CROWNE HEALTH CARE SUBDIVISION

<u>Engineering Comments:</u> <u>FINAL PLAT COMMENTS</u> (should be addressed prior to submitting the FINAL PLAT for acceptance and signature by the City Engineer):

The plat illustrates the proposed 1-lot, 4.8± acre subdivision which is located on the North side of Dauphin Street Service Road, 315'± West of Du Rhu Drive within Council District 7. The applicant states that the subdivision is served by city water and sanitary sewer systems. The purpose of this application is to create one legal lot of record from four legal lots of record.

APPLICATION NUMBER _____4 DATE October 6, 2016

DETAIL SITE PLAN

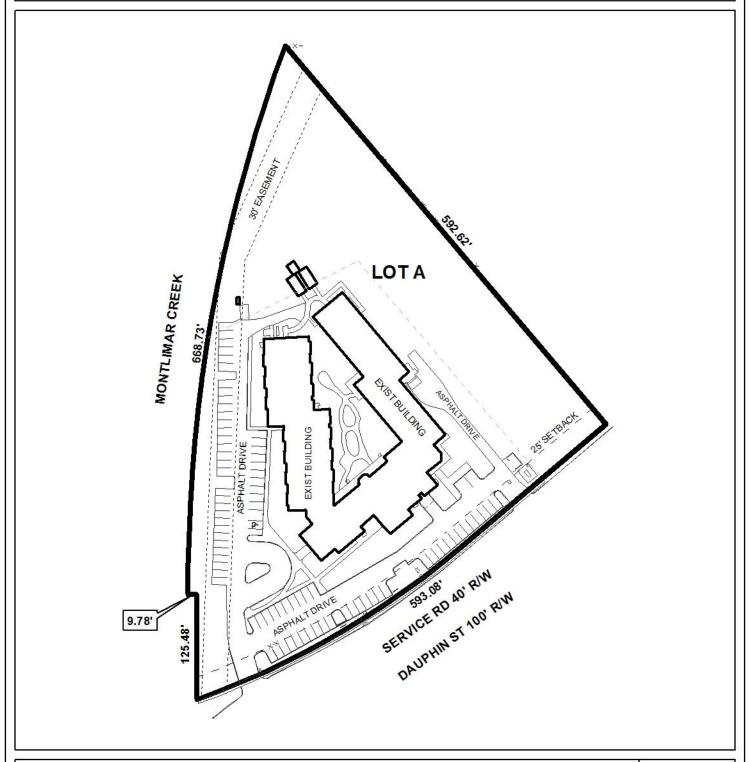
The subject site fronts Dauphin Street, a major street as illustrated on the Major Street Component of the Comprehensive Plan. As a major street, this street requires a 100' right-of-way width. The right-of-way width is depicted as 140' on the preliminary plat and should be retained on the Final Plat, if approved. The site is directly accessed by a service road along Dauphin Street.

It should be noted that the proposed lot also has frontage along Montlimar Creek. Montlimar Creek is a drainage canal sited along the western perimeter of the subject property. The right-of-way width of the creek is depicted as 100' wide on the preliminary plat; however, it appears that the right-of-way width varies from $120' \pm to 70' \pm to 7$

The subject property has a 30' Alabama Power Company easement sited along the western portion of the property adjacent to Montlimar Creek, and as such, should be retained on the Final Plat, if approved, along with a note stating that no structures are to be located in an easement.

The 25-foot minimum building setback line is depicted on the preliminary plat along Dauphin Street Service Road, and if approved, should be retained on the Final Plat.

As a means of access management, a note should be placed on the Final Plat stating that the site is limited to the existing curb cuts to Dauphin Street Service Road, with any changes to the size, location and design to be approved by Traffic Engineering and conform to AASHTO standards.

- 1) Retention of the right-of-way width along Dauphin Street;
- 2) Revision of the right-of-way width along Montlimar Creek;
- 3) Retention of the 30' Alabama Power Easement;

- 4) Provision of a note stating that no structures are to be located in an easement;
- 5) Retention of the 25' minimum building setback line along Dauphin Street Service Road;

- 6) Retention of the lot size information in both square feet and in acres;
- 7) Placement of a note on the Final Plat stating the site is limited to the existing curb cuts to Dauphin Street Service Road, with any changes to the size, location and design to be approved by Traffic Engineering and conform to AASHTO standards;
